REMARKS

In re Appln. Of: Gregory J. Momber
Application No.: 09/913,859

AMENDMENTS TO THE DRAWINGS

FIG. 2

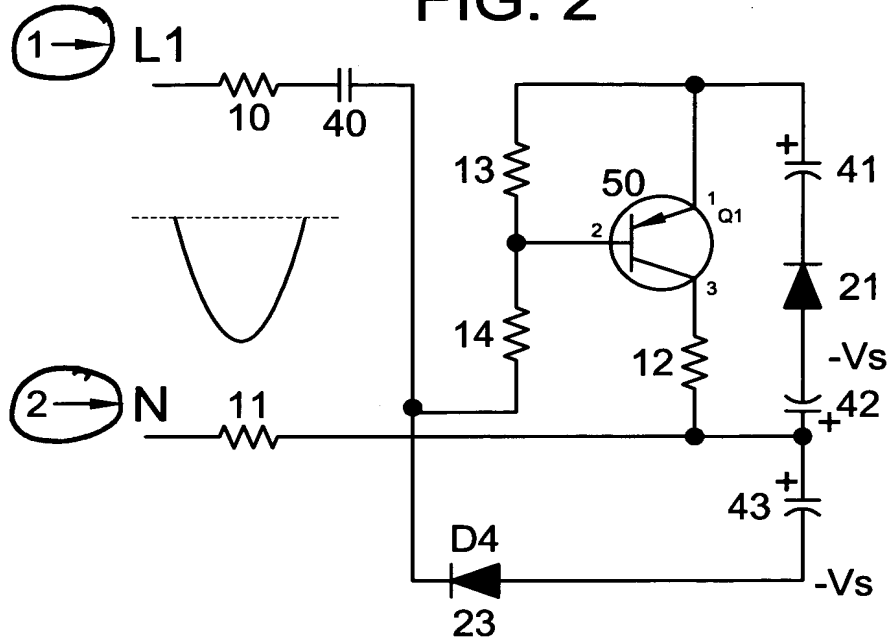
The Examiner has objected to the drawings under 37 CFR 1.84(p) because figures 1-9 contain numbers, letters, and reference characters smaller than 0.32 cm (1/8 inch) in height. Additionally, the Examiner objected to the drawing as failing to comply with 37 CFR 1.84(p)(5) because they do not include several reference signs mentioned in the specification. The applicant has submitted herewith corrected formal drawings for the Examiner's consideration. Reconsideration of these grounds of objection and indication of the acceptability of these drawings as amended are respectfully solicited.

The attached sheets include changes to Figs. 2, 4, 5a, 5b, 5c, and 5d.

The drawings have been amended to add the reference characters noted by the Examiner, and to provide proper sizing of the numbers under 37 CFR 1.84(p).
